GROUP	MODEL
Safety Recall Campaign	2023-2025MY K5 (DL3, DL3a)
NUMBER	DATE
SC346	November 2025

SAFETY RECALL CAMPAIGN

SUBJECT: **C-PILLAR GARNISH MOLDING REPLACEMENT (SC346)**

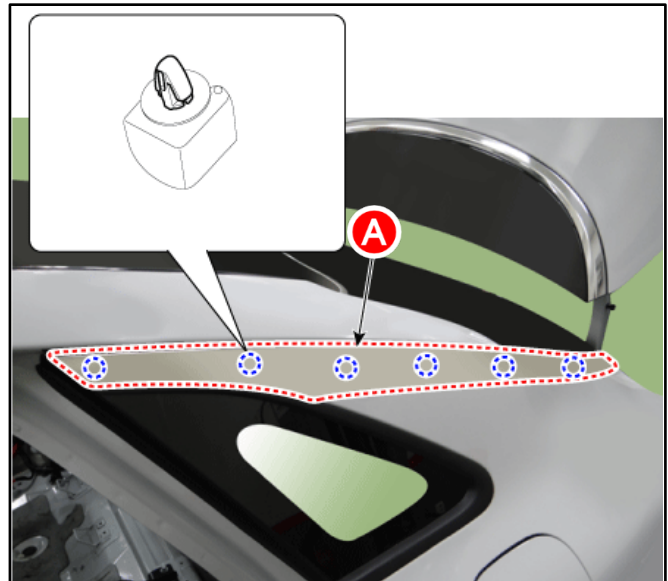
- Using a non-marring plastic trim tool, carefully pry with 'light' upward pressure in between the rear C-Pillar chrome garnish rubber and the body to detach the C-Pillar Garnish Molding (refer to the table above for the applicable VIN for the vehicle you are workin on).
- Replace the affected (Left and/or Right side) rear C-Pillar garnish (B) by referring to "Body (Interior and Exterior) → Quarter Fixed Glass → Repair Procedures (C-Pillar Garnish, step 2)" in the applicable Shop Manual in KGIS.

Note: The new C-Pillar garnish includes new clips.

Use extreme caution when removing the door belt outside weatherstrip(s). The faceplate can become sharp when detached and can cause serious injury.
